ADDRESS: 6333 MALVERN AVE

Proposal: Demolish non-historic buildings; construct dining hall, guard house, and drop-off area

Review Requested: Final Approval Owner: Overbrook School for the Blind

REPORT OF THE ARCHITECTURAL COMMITTEE OF THE PHILADELPHIA HISTORICAL COMMISSION

BEFORE AND AFTER: VIEW FROM BUS LOOP

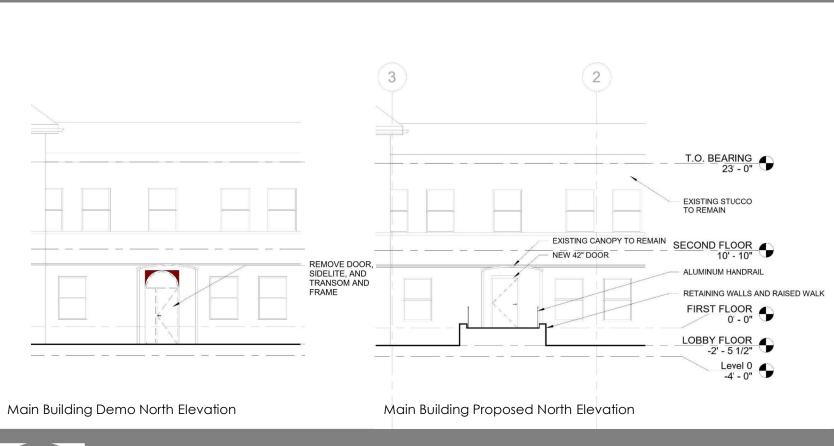
- Mr. Detwiler observed that the proposed new construction was respectful in terms of scale, detail, and materials and would not dominate the historic building. He inquired about the proposed elevator tower. Mr. Detwiler asked if the new tower is a blank box or would replicate the existing tower. He continued that the rendering shows the new tower with no detail on the exterior.

- o Mr. Horan responded that the area proposed for the elevator is an existing stair tower that was added at some point in the school's history and they plan to enlarge it to create an accessible elevator to the second floor. He noted the goal is to match the tower on the other side of the building. Mr. Horan said they were planning on replicating it in kind including the relief panels of the other tower.

BEFORE AND AFTER: NORTHWEST VEHICULAR ENTRANCE

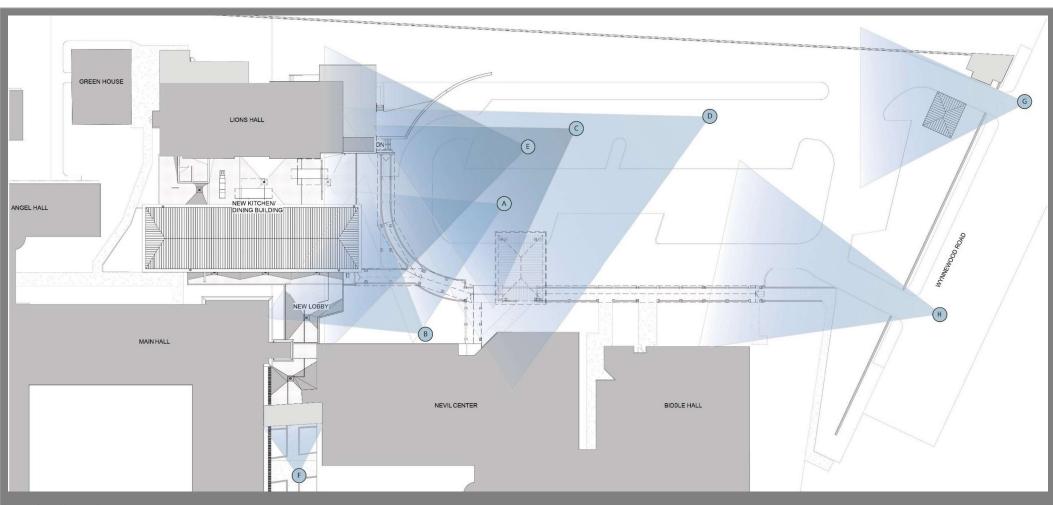
- Mr. Cluver asked about the new opening proposed for the historic campus wall, which will be visible to public view. He asked if the current vehicular entrance would be widened and added that it looked wider in the rendering when compared to the photographs.

- Mr. Cluver inquired how the width of the existing vehicular entrance compares to the proposed new opening for exiting the campus
 - o Mr. Horan replied that the exit drive would be slightly wider, approximately 20 feet wide. He noted for comparison that the existing entrance drive is approximately 18 feet wide. Mr. Horan said the new exit was planned slightly wider to help with sight lines when driving out of the new exit.

- o Mr. Detwiler said the new exit does seem wider and more dominant. He asked if they could be the same width.
 - Mr. Horan said they could review and see if the opening could be made narrower but would also need to make sure any change met the Street Department's requirements. He reminded the Committee members that it was a one-way exit. He added that they are not proposing to match the historic piers and the finials that are present on the historic vehicular entrance.

- o Mr. Horan replied that it would not be widened.
